**Southeast**  
Missouri State University

This letter is to clarify the issues you raised with respect to our amendment request to nuclear materials license No. 24-09296-02. Those issues are as follows:

Magill Hall Basement Level

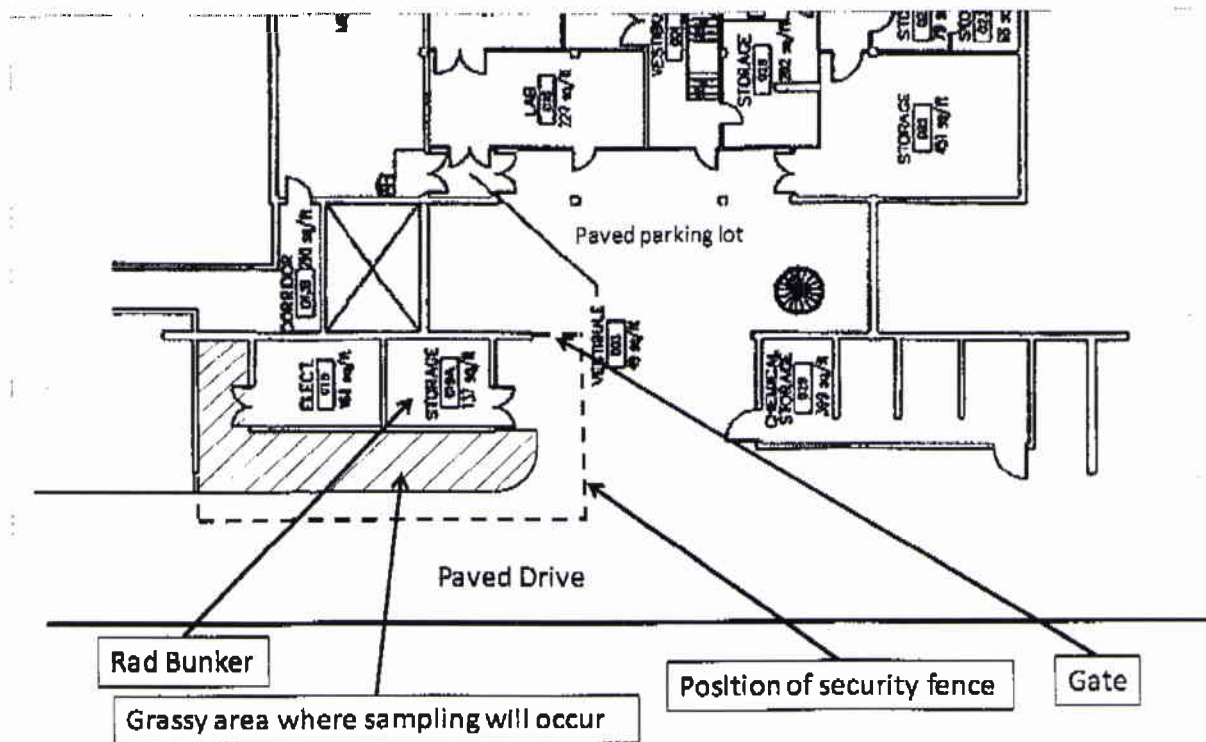
Confirm the area that will be restricted. It appears that the area of interest in your diagram is the shaded area. If so, confirm that the shaded area will be completely enclosed. Also specify the dimensions of the area.

***I have included a new diagram with this letter. The shaded area in the diagram is the grassy area. The dashed line represents the outline of the fenced in area. The fence adjoins a retaining wall on the west side which is 8 feet high. This retaining wall is connected to Magill Hall proper, and the walls there are 8 to 10 feet in height. This assures that no pedestrian entrance is possible without considerable effort and premeditation. The grassy area is approximately 8 feet wide by 42 feet long. The inset on the west side is about 10 by 10 feet. The entire enclosed area is about 20 feet by 44 feet.***
